Determination 2010/139

The refusal to grant a waiver of Building Code Clause F4 for a deck barrier at 28B Howard Road, Northcote, North Shore (to be read in conjunction with Determination 2007/08)

Figure 1: The barriers to the decks and landing

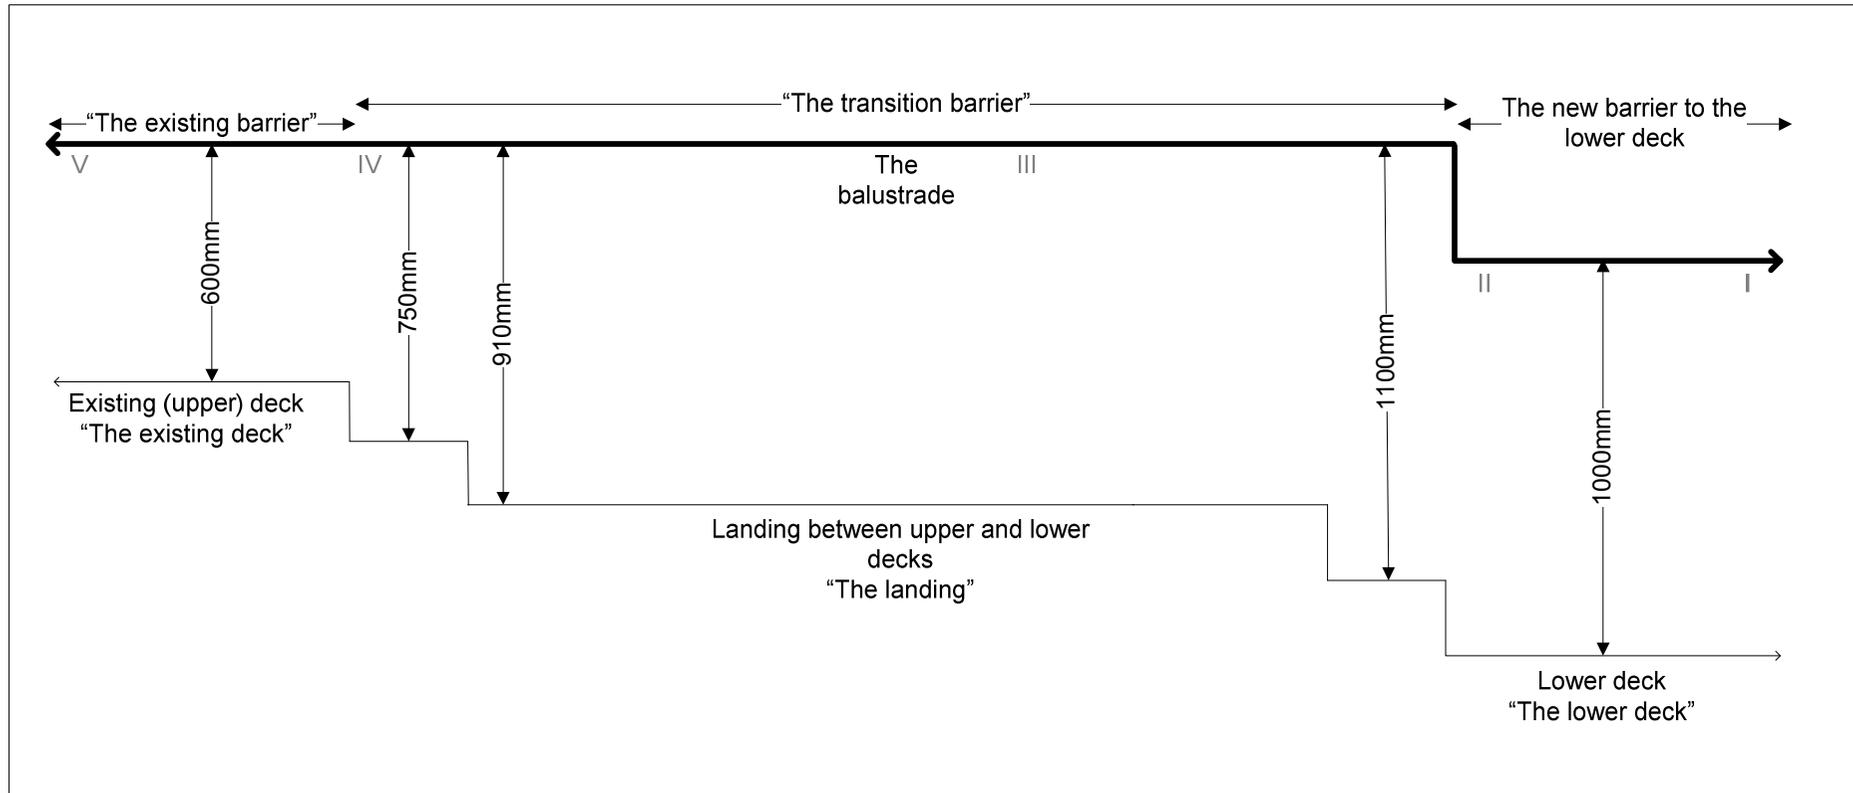
- 5.3 It is my view that I must consider whether the height of the barriers affords adequate protection to people at each of the areas of the deck (refer to Figure 1):

- Area V the barrier beside the upper deck.
- Area I The barrier beside and adjacent to the lower deck**
- 5.4 Table 1 of F4/AS1 requires a barrier height of 1000mm at balconies and decks of household units. The barrier beside the lower deck area measures 1000mm and therefore complies with F4/AS1.

- 5.8 Table 1 of F4/AS1 requires a barrier height of 900mm at stairs. The barrier at the landing area is 910mm and therefore complies with F4/AS1.
- 5.9 While the landing is significant in size, I consider it is reasonable to consider it a landing in this instance because it forms the sole outside route between the upper and lower decks, and because of the large size of the decks themselves. People are unlikely to congregate or linger in the landing area itself.

- 5.13 The 600mm barrier beside the upper deck is existing. The existing barrier is not required to comply fully with the Building Code as it was built before the former Act came into effect. The building, after the alteration is required to comply to the same extent as before the alteration (refer to paragraph 5.2) with respect to Clause F4.
- 5.14 However, I consider that the stair between the upper deck and landing area is a potential tripping hazard (refer to paragraph 5.11) and it is my view lessens the extent of the compliance of the 600mm existing barrier i.e. there is a greater likelihood of accidental fall due to the presence of the stair than before the alteration.
- 5.15 This is only the case in the zone where the transition barrier meets the existing barrier.

Figure 2: Area II showing the pitch line and area where the barrier is less than 900mm

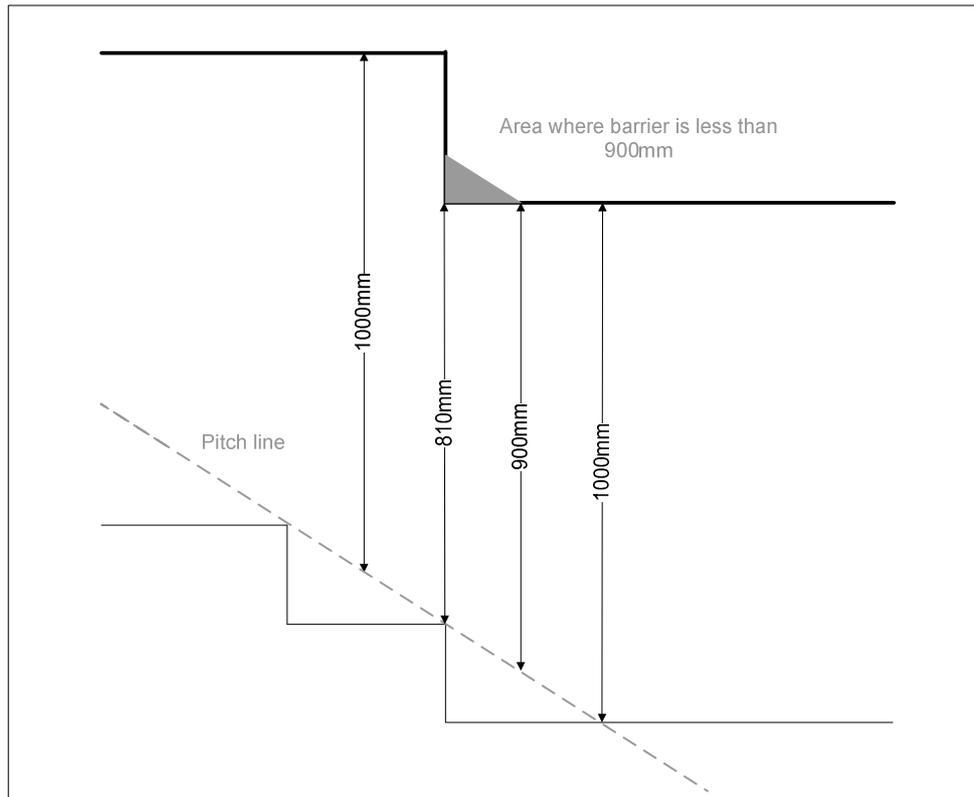
- Area II The barrier beside and adjacent to the stair between the landing and the lower deck**
- 5.5 Table 1 of F4/AS1 requires a barrier height of 900mm at stairs and landings. This is measured from the pitch line (the line joining the leading edge of nosings or successive stair treads).

- 5.6 Figure 2 shows there is a small area where the height of the barrier is less than 900mm, however, this is less than 150mm in length and in general the barrier beside and adjacent to the stair between the landing and the lower deck are compliant.

- 5.7 F4/AS1 is only one way to comply with the performance requirements of the Building Code and it is my view that this area of the barrier complies with Clause F4 in that the barrier is of an adequate height to reduce the likelihood of accidental fall.

Figure 3: Area IV showing the pitch line and area where the barrier is less than 900mm

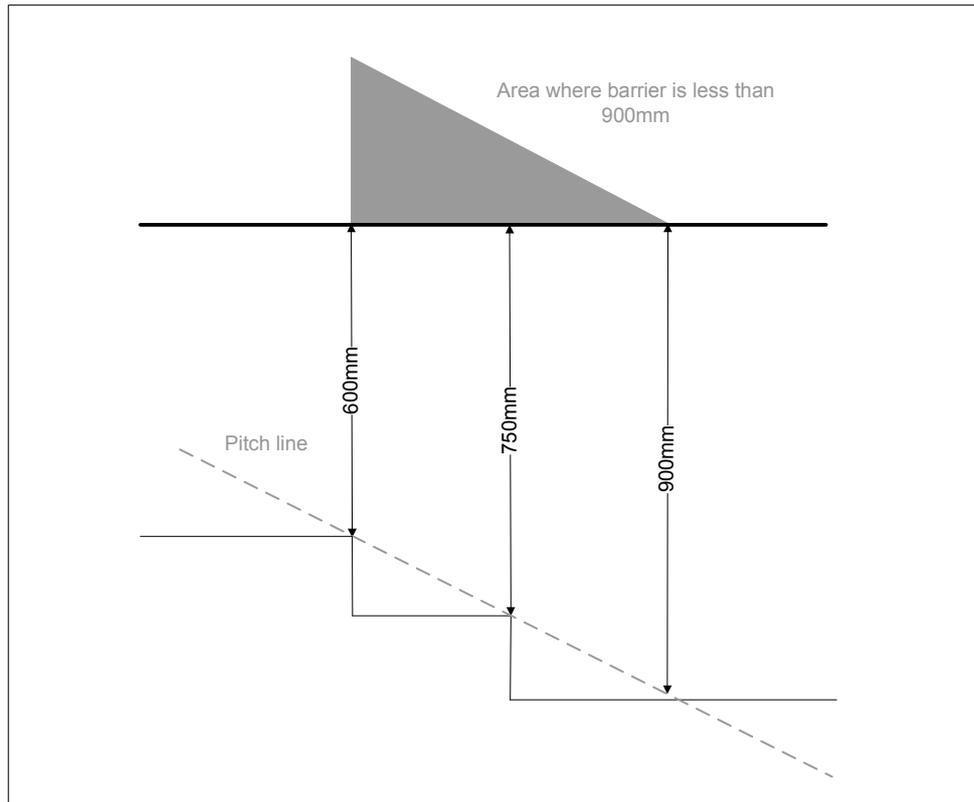
- 5.10 The barrier beside the stair between the landing and existing deck is between 600mm and 900mm from the pitch line of the stair. Figure 3 shows the area where the barrier is less than 900mm at the stair between the landing and existing deck.
- 5.11 I consider that the steps between the upper deck and landing area create a potential tripping hazard. A person stepping from the stair to the existing deck area is protected by a barrier that is significantly less than the 900mm required by F4/AS1 at that point.
- 5.12 The transition barrier to Area IV is in my view too low to provide protection for anyone who may trip or stumble at the steps when using the stair.

- 5.16 I consider that the transition barrier does not comply with Clause F4 because the barrier beside the stair between the landing and upper deck is not of an adequate height to reduce the likelihood of accidental fall.
- 5.17 I consider that the existing barrier adjacent to the stair does not comply to the same extent as before the stair and transition barrier was added, as the presence of the stair creates a hazard that was not there before the alterations were completed.

- 6.7 Possible solutions could include:
- installing a permanent and fixed obstruction where the existing barrier and transition barrier meet, such as a planter box

- providing a handrail to the area where the existing barrier and transition barrier meet
 - modifying the configuration of the barriers, so the transition barrier complies with the Building Code, and the level of compliance of the existing barrier is increased.

6.8 If the applicant selects a solution such as installing an obstruction such as a small planter box at the junction of the existing barrier and transition barrier, it is my view that the transition barrier would then comply with the Building Code, and the existing barrier would comply to the same extent as before the step was added. The obstruction would eliminate the tripping hazard and reduce the likelihood of accidental fall. I note that a waiver of Clause F4 would not be required in this case.
